LARAMIE COUNTY PLANNING & DEVELOPMENT DEPARTMENT

MEMORANDUM

TITLE: PUBLIC HEARING on a Subdivision Permit and Plat for Fertig Ranch subdivision, Situated in the NW ¼ of Section 11, T14N, R65W of the 6th P.M., Laramie County, WY.

Permit Number: PZ-24-00094

MAP OF SURVEY for RECCO TRACTS

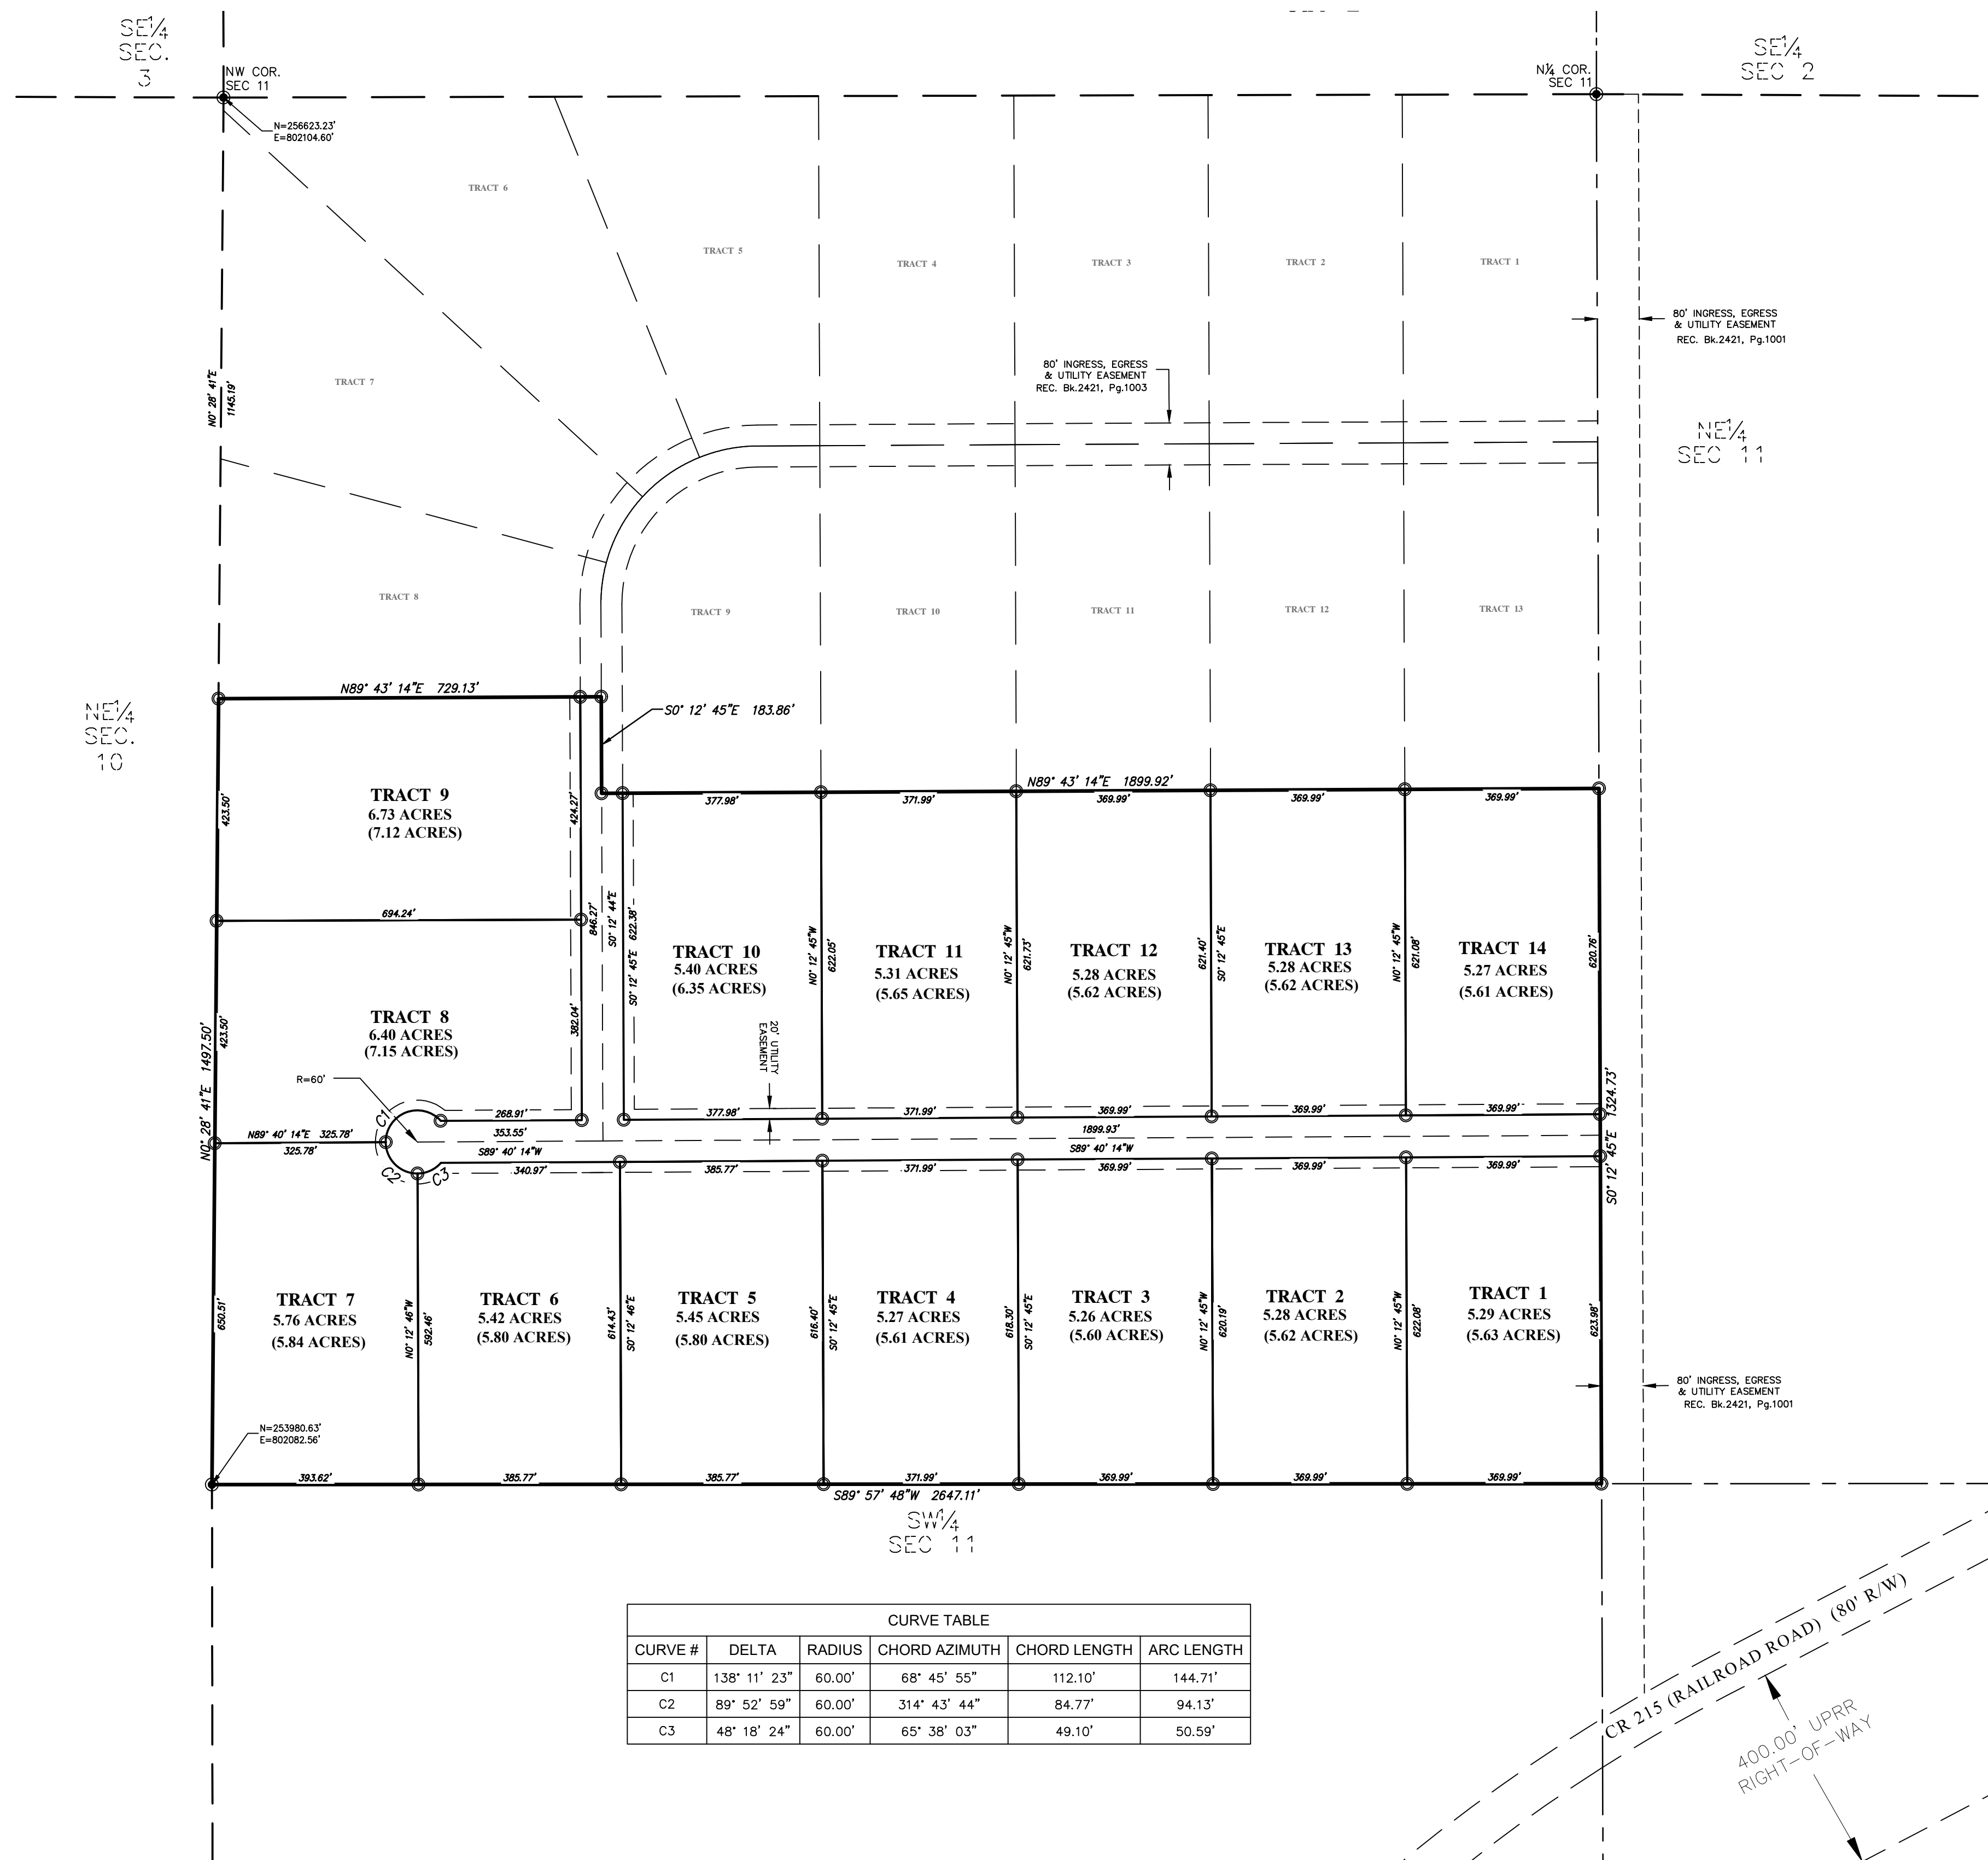
4.The plat drawing indicates the area is served by LCFD No. 3, but it should be served by LCFA.

5.Since it appears this plat is dedicating the ROW for the roadways, names for the roadways should be provided. In addition, the widths of the ROW need to be labeled on the plat.

7.In the Dedication, there are two bearings that dont match the bearings labeled on the plat drawing. One is N89 degrees 4314W versus N89 degrees 4314E, and the other is N0 degrees 2811E versus N0 degrees 2841E.

1.Is the southwest corner of this subdivision the West Corner of Section 11, if so it should be labeled.

2.The differences of bearings and distances between this subdivision and the RECCO TRACTS records of survey are not shown on this plat.

3.The VACATION STATEMENT on this plat describes the vacation of an ACCESS EASEMENT recorded in BOOK 2421, AT PAGE 1001, however the RECCO TRACTS records of survey state that the easement is recorded at PAGE 1003. Are these referencing the same easement?

4.There is one label identifying a 20 UTILITY EASEMENT, however there is more than one easement shown on the plat. Either a note or an additional label would help clarify intent.

<p>1. Acknowledged</p> <p>2. Corrected</p>	
					<p>THE ONLY THING THAT CHANGED WITH THIS ALREADY APPROVED PLAT IS THE REMOVAL OF 1 TRACT.</p>	
06/02/2026		Workflow	PUBLIC WORKS REVIEW	DEFICIENCY	<p>1. No responses to comments submitted. The following comment still apply:</p> <p>a. The comment responses seem to contradict each other. The review engineer mentioned building of the roadways and the response comment indicated that would not be done. Public Works made a comment regarding the roadways needing to be built (inside and outside the plat boundary), and that was acknowledged. So which is it?</p> <p>b. the following comment from Public Works still stands:</p> <p>b1. With this development, the ingress, egress and utility easements shown on the plat and those outside the boundaries of this plat (Book 2421, Pg 1001 and Book 2421, Pg 10003) shall be designed and built to the current Laramie County Land Use Regulations. The road construction design plans shall be submitted to Laramie County Public Works for review and approval prior to construction taking place.</p> <p>b2. Raymond Trail and Recco Ranch Road shall also be built to County Standards.</p> <p>2. I agree with the comments provided by the review engineer.</p>	MOLLY.BENNETT@LARAMIECOUNTY.WY.GOV

<p>1. responses were submitted to previous comments.</p> <p>2. It will be done as indicated previously.</p> <p>3. Acknowledged</p> <p>4. Acknowledged</p> <p>5. Acknowledged</p> <p>6. Acknowledged</p>

FERTIG RANCH

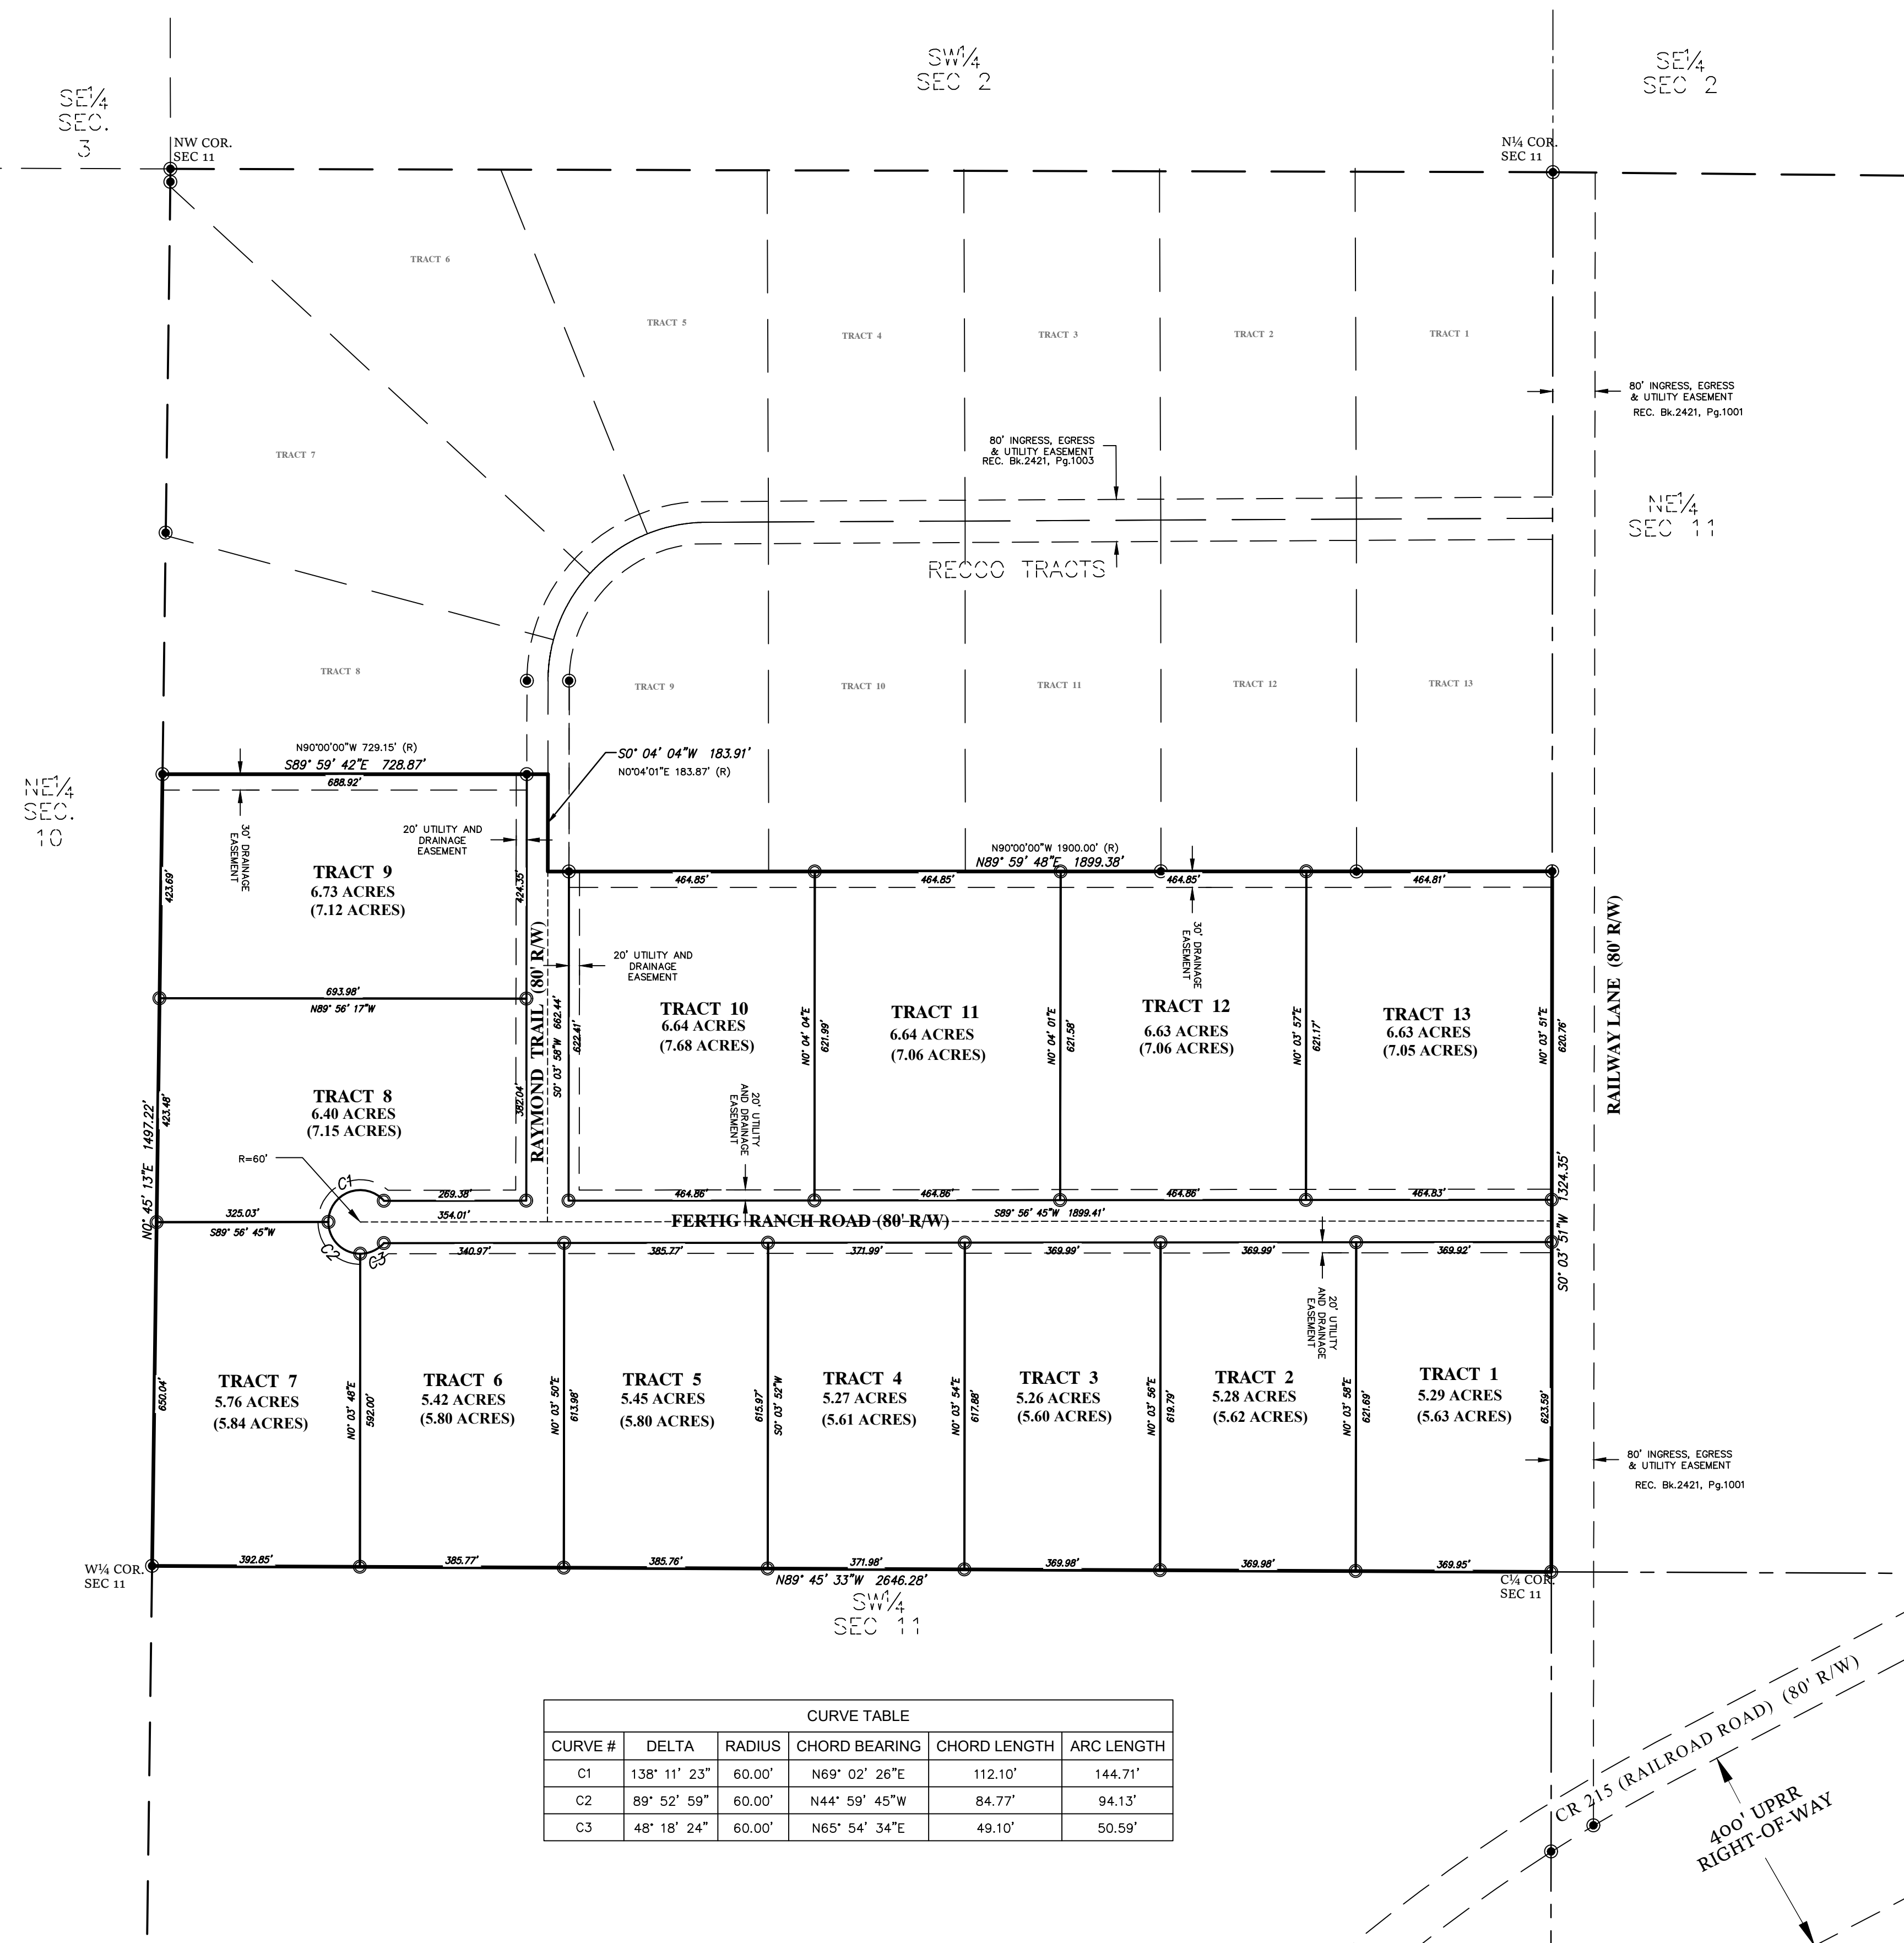
06/02/2026		Workflow	PUBLIC WORKS REVIEW	DEFICIENCY	<p>1. No responses to comments submitted. The following comment still apply:</p> <p>a. The comment responses seem to contradict each other. The review engineer mentioned building of the roadways and the response comment indicated that would not be done. Public Works made a comment regarding the roadways needing to be built (inside and outside the plat boundary), and that was acknowledged. So which is it?</p> <p>b. the following comment from Public Works still stands:</p> <p>b1. With this development, the ingress, egress and utility easements shown on the plat and those outside the boundaries of this plat (Book 2421, Pg 1001 and Book 2421, Pg 10003) shall be designed and built to the current Laramie County Land Use Regulations. The road construction design plans shall be submitted to Laramie County Public Works for review and approval prior to construction taking place.</p> <p>b2. Raymond Trail and Recco Ranch Road shall also be built to County Standards.</p> <p>2. I agree with the comments provided by the review engineer.</p>	MOLLY.BENNETT@LARAMIECOUNTY.WY.GOV
